Midland Independent Design and Construction Verification Program

Structural Evaluation of the Diesel Generator Building

Re: Docket Nos. 50-329 OM, OL and 50-330 OM, OL
Midland Nuclear Plant - Units 1 and 2
Independent Design and Construction Verification (IDCV) Program
Structural Evaluation of the Diesel Generator Building -
Assessment of the Structural Performance Capability as
Potentially Affected by Settlement Induced Cracking

STRUCTURAL EVALUATION OF THE DIESEL GENERATOR BUILDING -
ASSESSMENT OF THE STRUCTURAL PERFORMANCE
CAPABILITY AND SERVICEABILITY AS POTENTIALLY AFFECTED
BY SETTLEMENT INDUCED CRACKING

FIGURE 6-3
DIESEL GENERATOR BUILDING
SOUTH WALL
SETTLEMENT INCREMENT

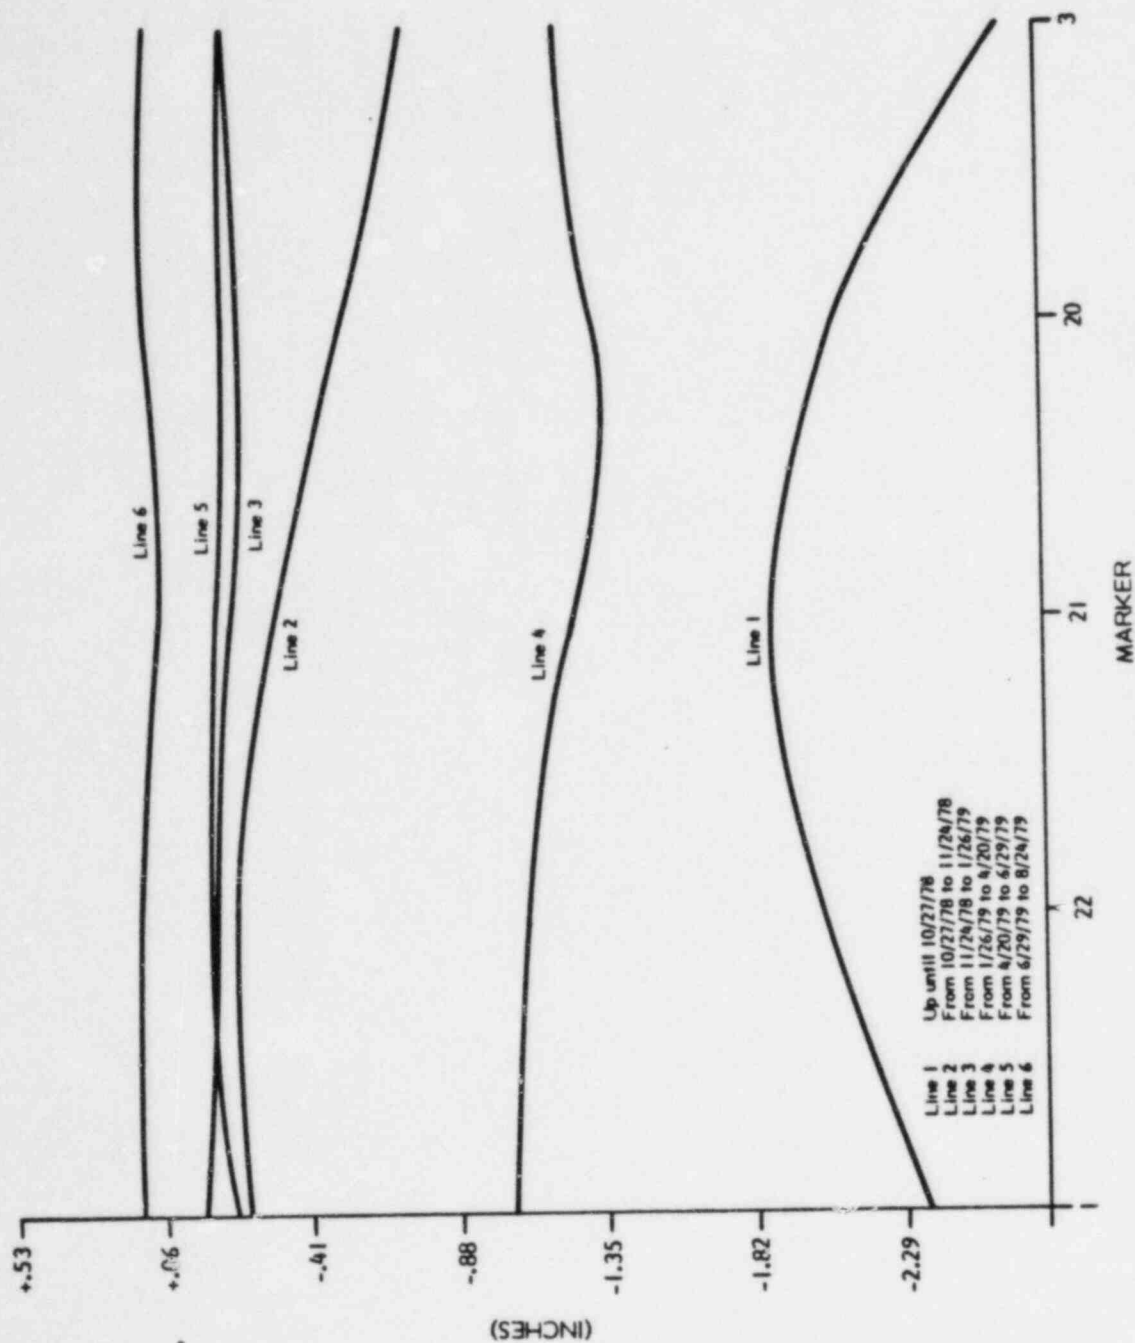
Figure 6-3 shows the incremental settlement for 6 time periods between July 1978 and August 1979 for the south wall of the DGB. The first three measurements show large differential deformations and introduction of curvature in the wall. The latter ones show stabilization of differential settlements implying that the wall is still settling but as a rigid unit, introducing little additional in-plane bending. For more recent recordings the stabilizing trend is even more noticeable. Study of the foundation curvature variation and deformation of the building with respect to its rigid body motion point toward the same trend. This is supported by an evaluation discussed in reference 4, where it was noted that the settlements occurring during the time periods represented by lines c and d (reference 4, figure DGB-7), were those that are expected of a rigid body. In figure DGB-7, line c represents settlement during the surcharging period (1/79 - 8/79) and line d represents estimated settlement during the post-surge period (9/79 - 12/2025). The point here is that the early cracking occurred when the building was only partially completed. Upon completion, the five sided (four walls and a roof) structure is now responding as a stiffer, essentially rigid body as would be expected.

Hence during its construction stage, the building underwent substantial differential settlement that introduced in-plane curvature in the walls with resulting stress and cracking compounded with normal shrinkage cracking. As the building was completed and the concrete aged, it tended to behave more and more as a rigid unit, the whole foundation (or building) moving as a plane (or a unit). The recent data indicates that for the last four years the building has generally settled as a rigid body introducing relatively little additional distortion in the structure. We expect this behavior to persist in time.
